AUXILIARY POWER - APU BLEED DUCT REPLACEMENT

700 Citation Longitude

SL700-49-01
Page 1 of 6

Figure 1. APU Bleed Air Duct (Sheet 1)

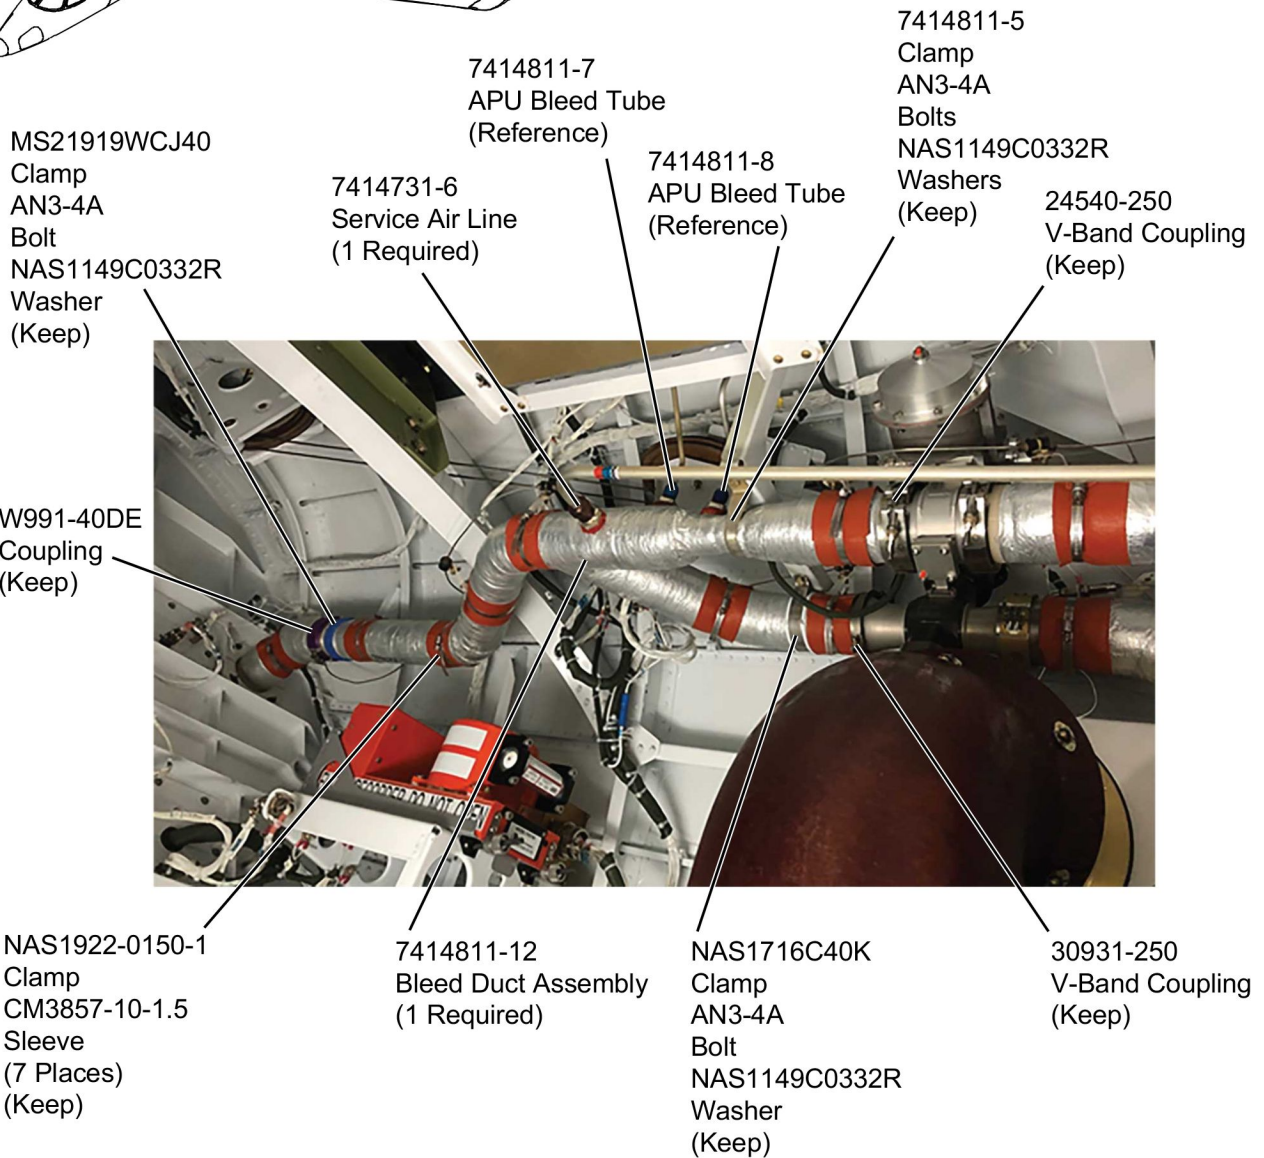
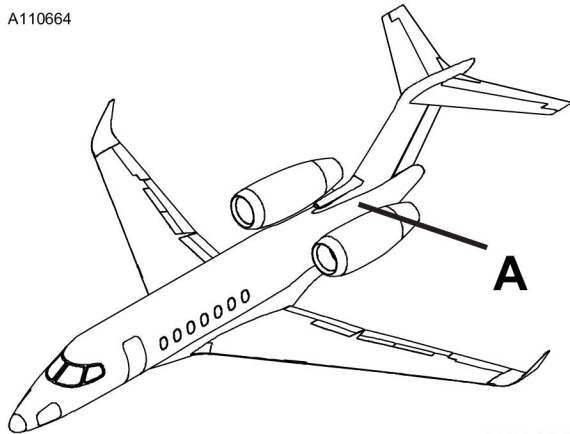
APU bleed duct may leak due to weld failure.

3. Open the tailcone access door. (Refer to the 700 Maintenance Manual, Chapter 52, Service Doors - Description and Operation.)
 - A. (Refer to Figure 1, Sheet 1.) Remove the 7490705-11 APU Bleed Duct Assembly.

- (12) Remove the bleed duct assembly from the airplane and discard.
- B. (Refer to Figure 1, Sheet 1.) Install the 7414811-12 Bleed Duct Assembly.
 - (1) Remove the protective wrap and caps from the bleed duct assembly.

- (2) Put the 7414811-12 Bleed Duct Assembly in to position in the airplane.
 - (3) Install the kept AN3-4A Bolt, NAS1149C0332 Washer and MS21919WCJ40 Clamp that attaches the aft end of the bleed duct assembly.

- (4) Install the two kept AN3-4A Bolts, NAS1149C0332R Washers and NAS1716C40K Clamp that attach the forward end of the bleed duct assembly.
 - (5) Install the two kept AN3-4A Bolts, NAS1149C0332R Washers and 7414811-5 Clamp that attach the forward end of the bleed duct assembly.

- (6) Install the AS3209-230 Packing on the aft end of the bleed duct assembly.
 - (7) Install the W991-40DE Coupling. (Refer to the Citation Standard Practices Manual, Chapter 20, Bleed Air Couplings - Maintenance Practices.)

- (8) Install the 13866-250 E-Seal with the 30931-250 V-Band Coupling and torque to the correct value as shown on the coupling. (Refer to the Citation Standard Practices Manual, Chapter 20, Bleed Air Couplings - Maintenance Practices.)

- (9) Install the 24540-250 V-Band Coupling and torque to the correct value as shown on the coupling. (Refer to the Citation Standard Practices Manual, Chapter 20, Bleed Air Couplings - Maintenance Practices.)
